COMPANY / PROJECT
ST185 CELICA GT-FOUR - LINK ECU CONVERSION

TITLE
LOGIC BOX - COVER

PART / DWG NO.	REV	MATERIAL
ST185-FB-107	M	PA12 (SLS / MJF)

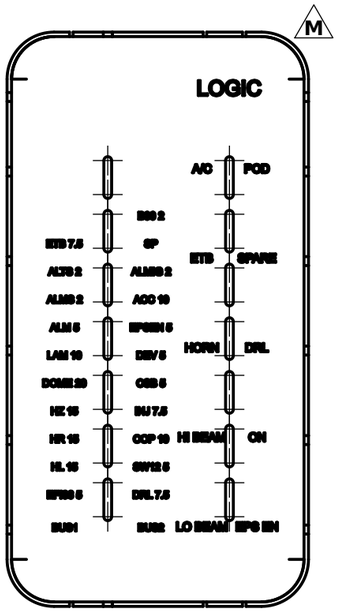
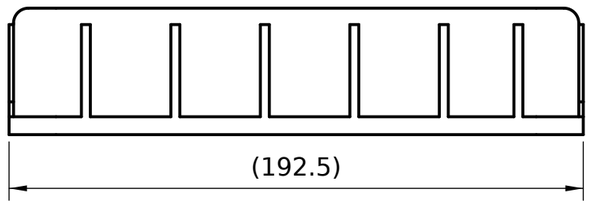
REVISIONS			
REV	DESCRIPTION	BY	DATE
F	Wall sweep: every R127 spot fixed or a named exemption (R128) (#270)	DG	16/10/26
G	R127 amendment: outer walls grown outward to 4.3, curved bend saddles back (#271)	DG	16/10/26
H	Dan's N2 / N3 / N4 answers (#273); first drawing issued (#280)	DG	16/10/26
J	Dan's markup 17/10/26 (23-21): fuse labels follow the respaced fuse grid	DG	18/10/26
K	N21 18/10/26 (R166): 3.15 wider with the LOGIC box; labels follow the fuse columns	DG	18/10/26
M	Fuse box rev 8 (Dan A15 b): etched cover labels follow the rev 8 fuse and relay map (K- names, SPARE seats)	DG	13/11/26
